# CITY OF PORTLAND

# BUILDING PERMIT

Job ID: 2012-07-4399-NEWCOM

**From:** Jeanie Bourke [mailto:[JMB@portlandmaine.gov](mailto:JMB@portlandmaine.gov)]  
**Sent:** Wednesday, August 22, 2012 9:28 AM  
**To:** Barry Yudaken  
**Subject:** Re: FW: Plan review 81 Danforth BP# 2012-07-4399

ITEM 5

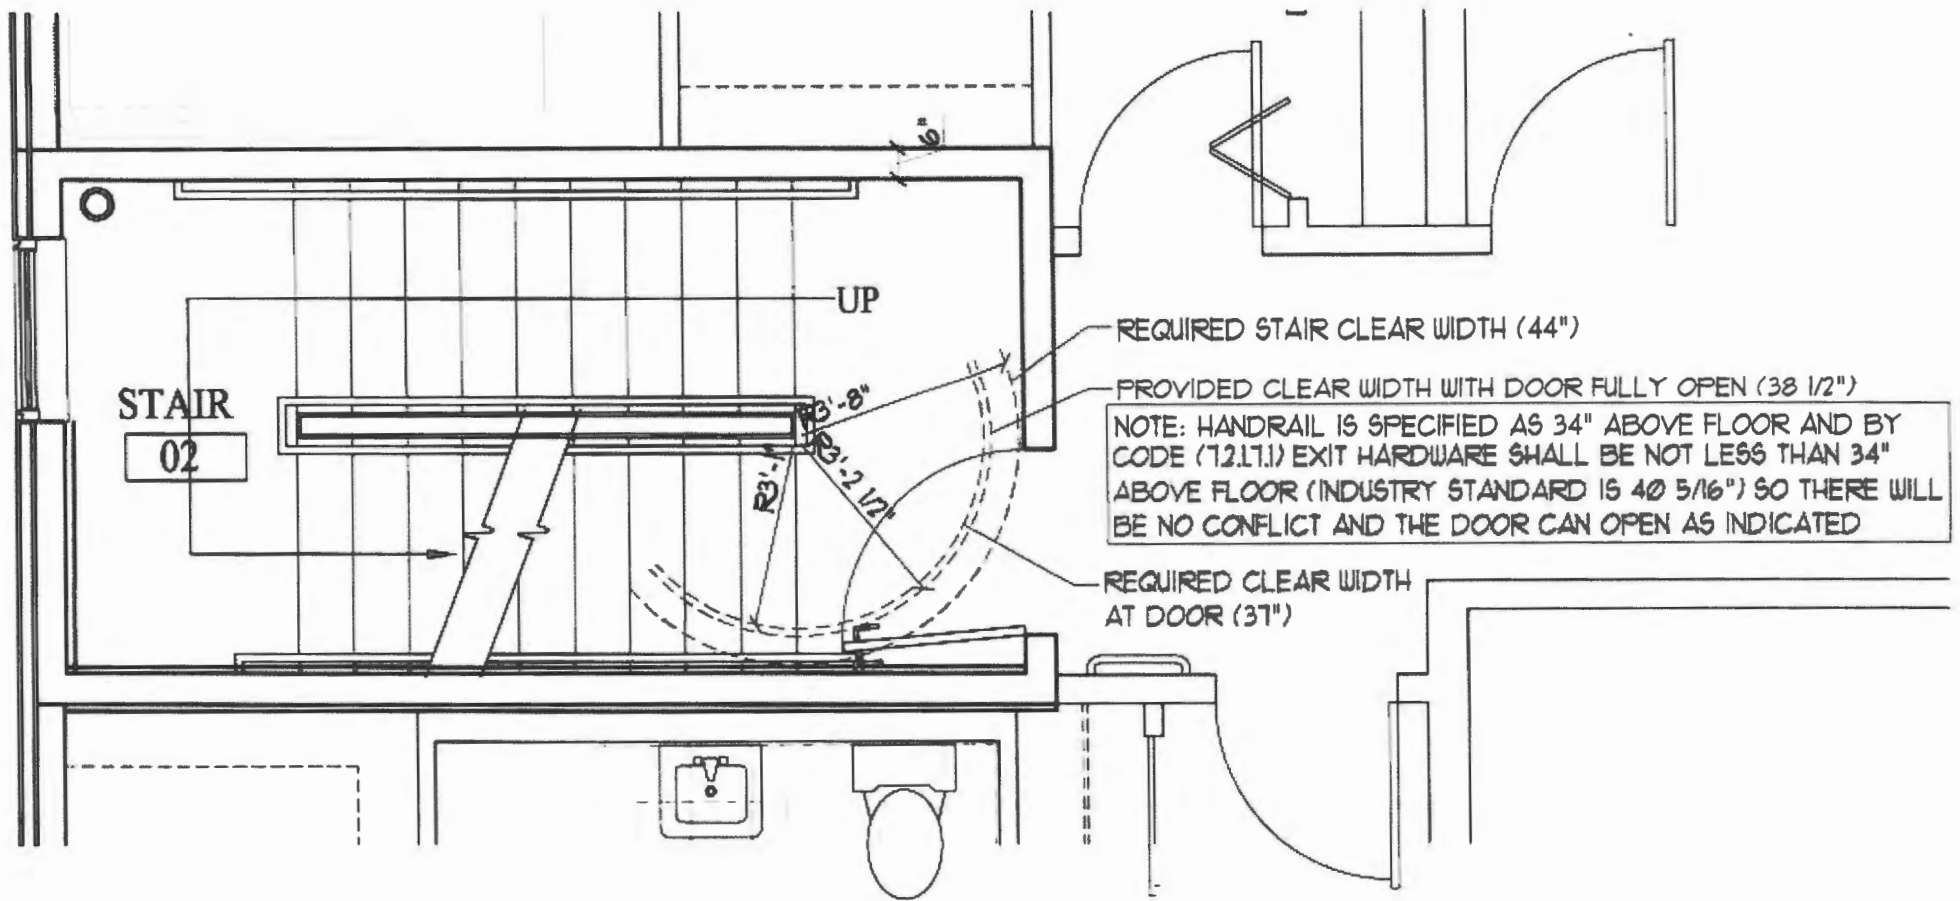
REQUIRED STAIR CLEAR WIDTH (44")

PROVIDED CLEAR WIDTH WITH DOOR FULLY OPEN (38 1/2")

C | STAIR 2 SECTION  
SCALE: 1/4" = 1'-0"

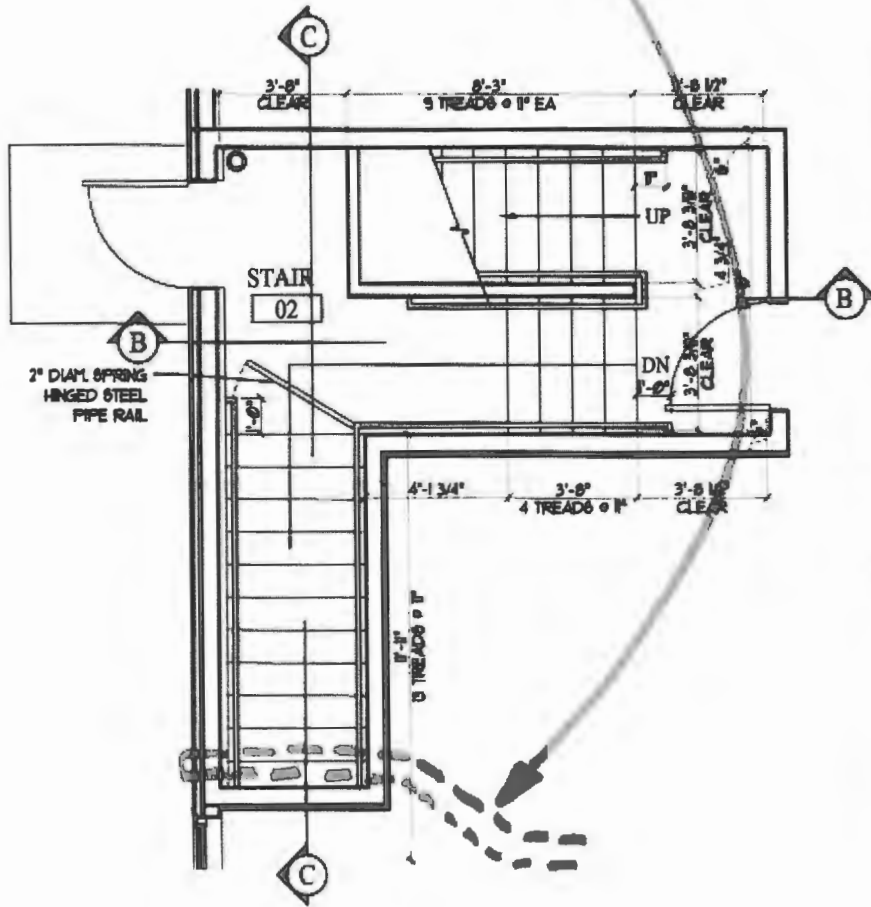
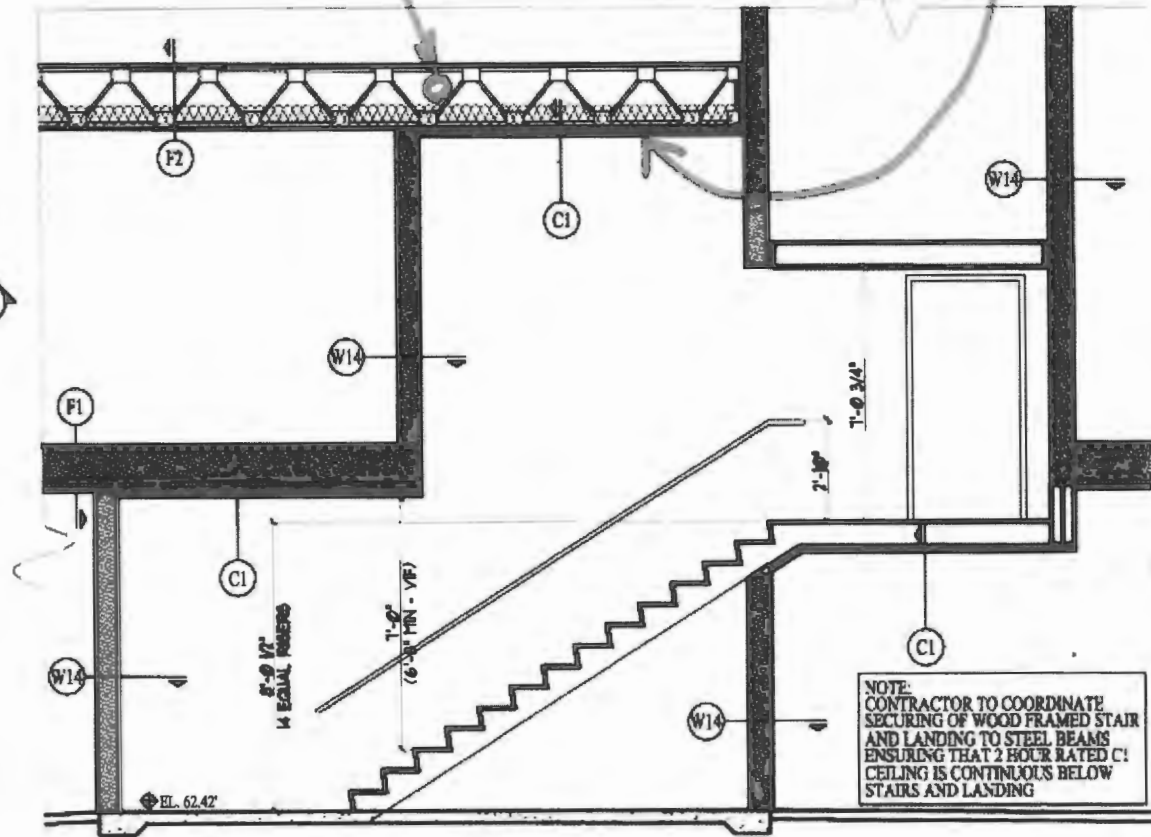
DUCTWORK IS IN CEILING SPACE

RATED ASSEMBLY (CI) IS BELOW DUCTWORK

7. Clarify if the range hood exhaust on Plan M-7 enters the 2 hour rated stair enclosure **THE EXHAUST DUCT DOES NOT PENETRATE THE STAIR ENCLOSURE. IT IS LOCATED IN THE TRUSSES ABOVE THE RATED CEILING C1 ABOVE THE STAIR ENCLOSURE**  **SEE SECTION C OF STAIR 2 ON DRAWING A3.22**

**A2.01**

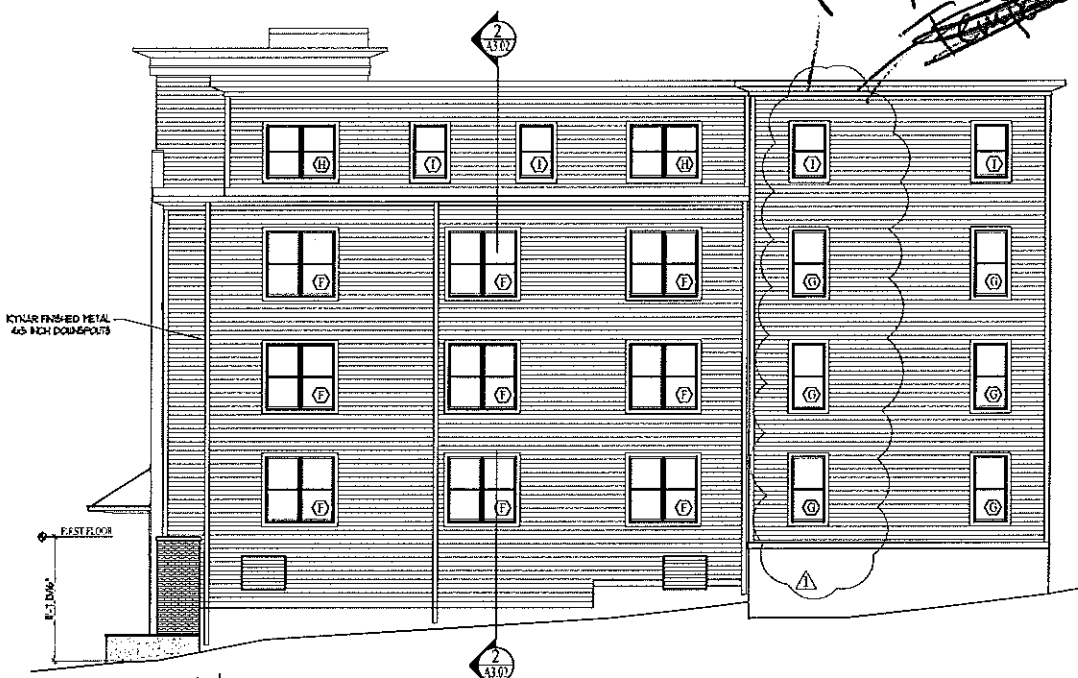
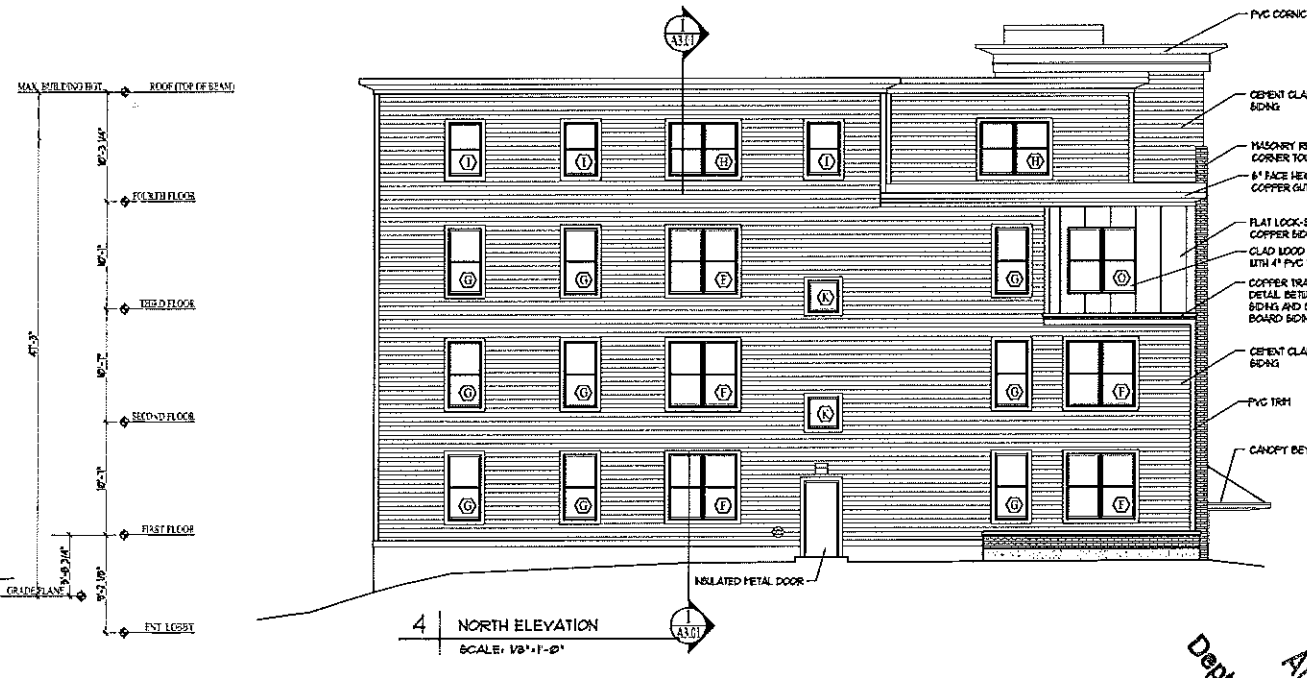
5. Provide code review and site plan details for exterior wall separation window protection percentage per Table 705.8 **SITE PLAN SHOWING SEPARATION DISTANCES AND CODE REQUIREMENTS PER TABLE 705.8 HAS BEEN ATTACHED. NOTE THAT THE WINDOWS ON THE EAST ELEVATION HAS BEEN REVISED TO COMPLY**  
 **THE REVISED EAST ELEVATION ON DRAWING A2.01 IS ATTACHED**

*Reduced % of glazing*

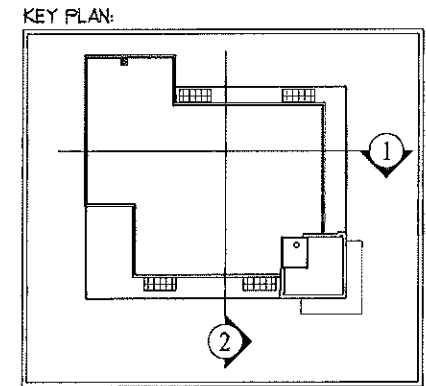
4. Note that the steps/railing to a roof balcony on Plan A3.02 have been removed **THESE HAVE BEEN REMOVED**

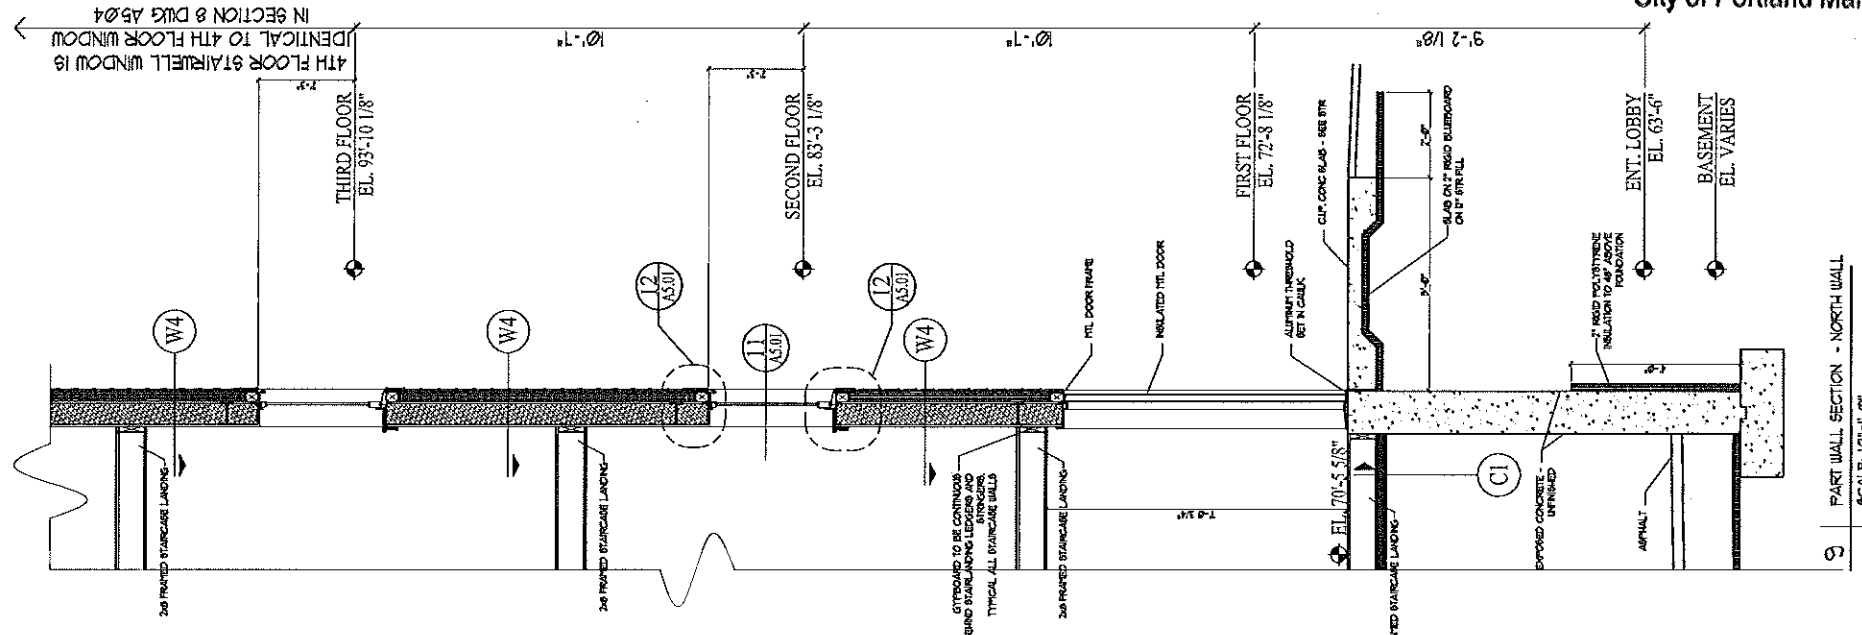
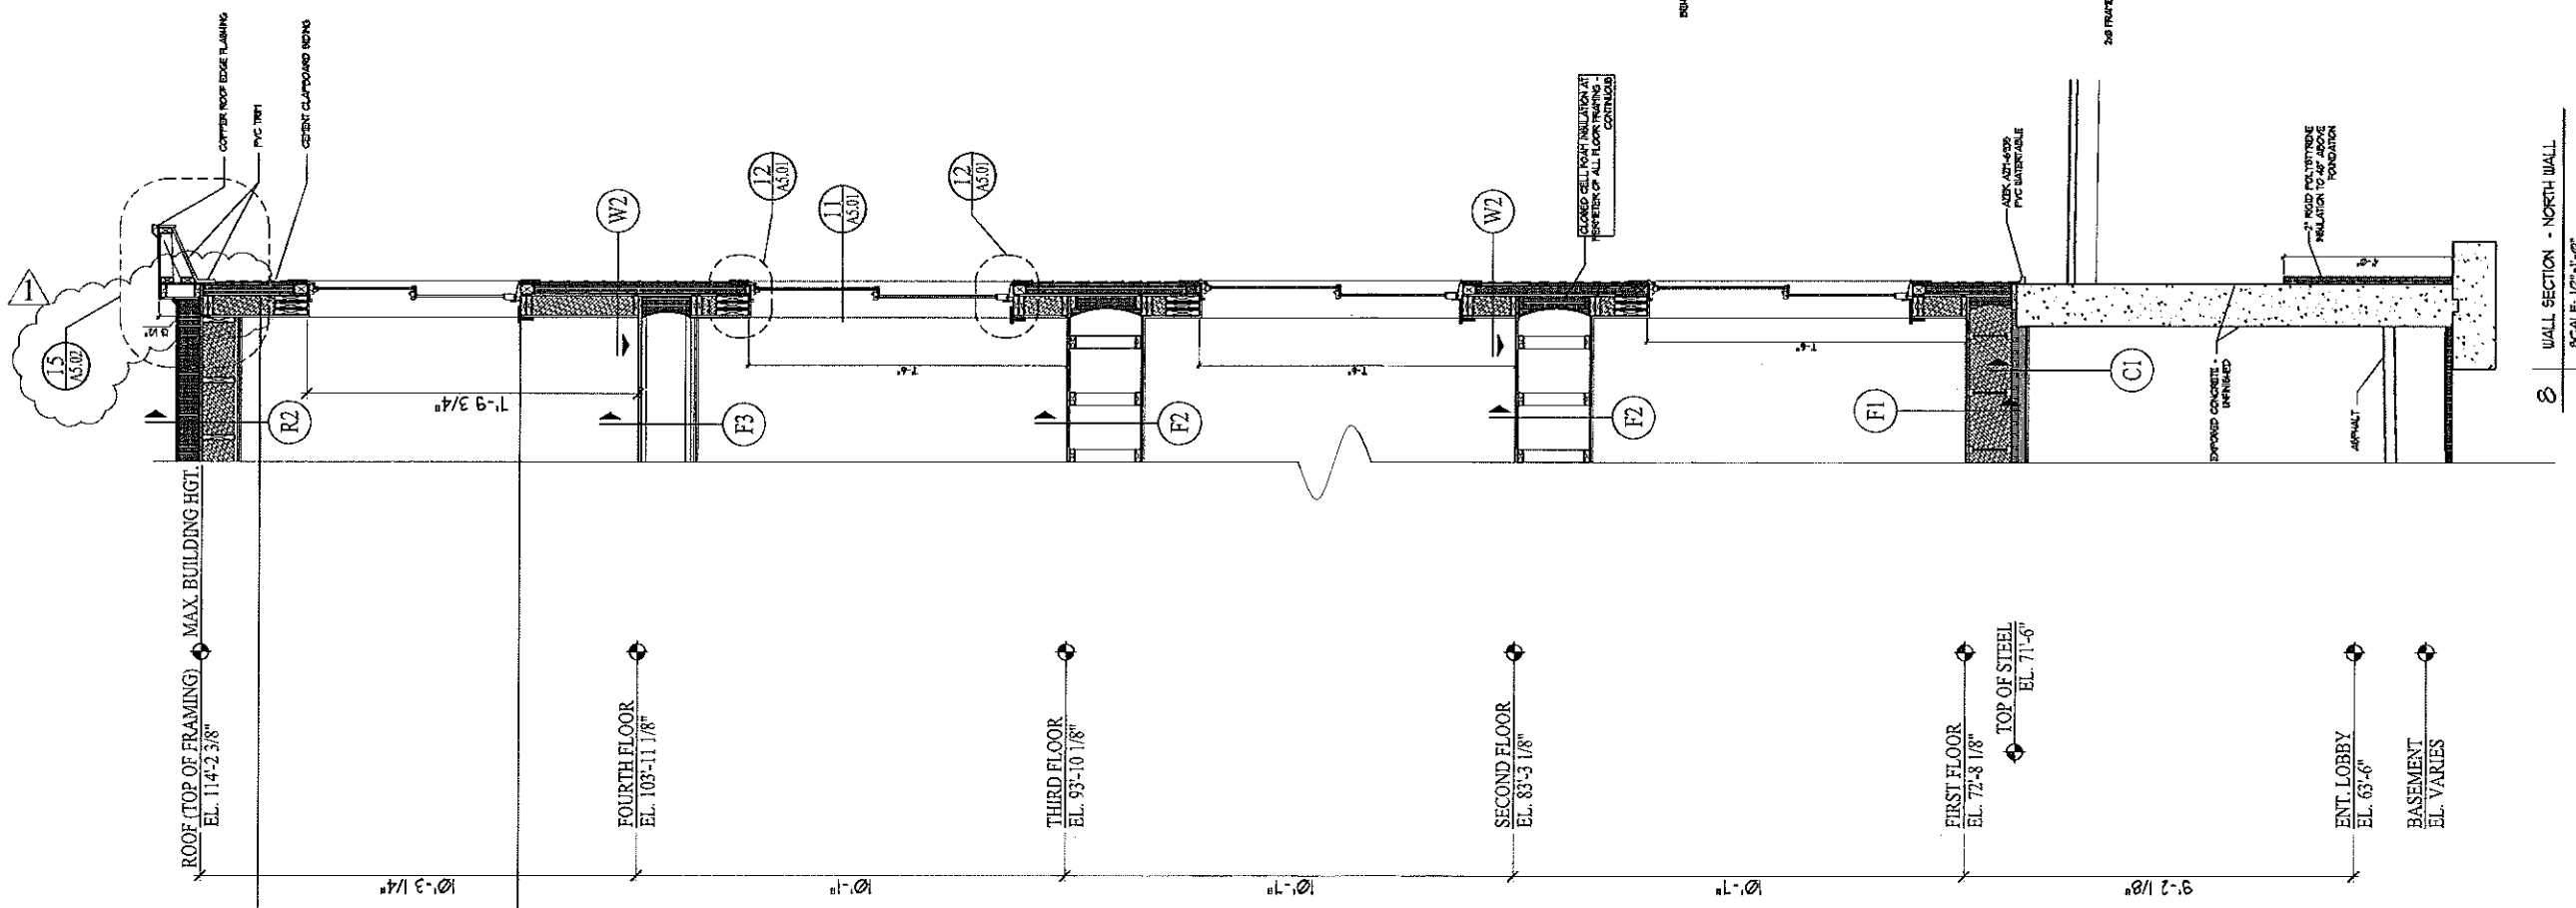
6. Provide the same for parapet requirements per Sec. 705.11 **THE WALL/ROOF DETAIL HAS BEEN REVISED WITH THE WALL NOW TERMINATING AT THE UNDERSIDE OF THE ROOF SHEATHING IN TO COMPLY WITH 705.11, EXCEPTION NO 4. THE REVISED WALL SECTIONS (DWG A3.12 & A3.13) AND REVISED DETAIL (A5.02, DETAIL 15) ARE ATTACHED**
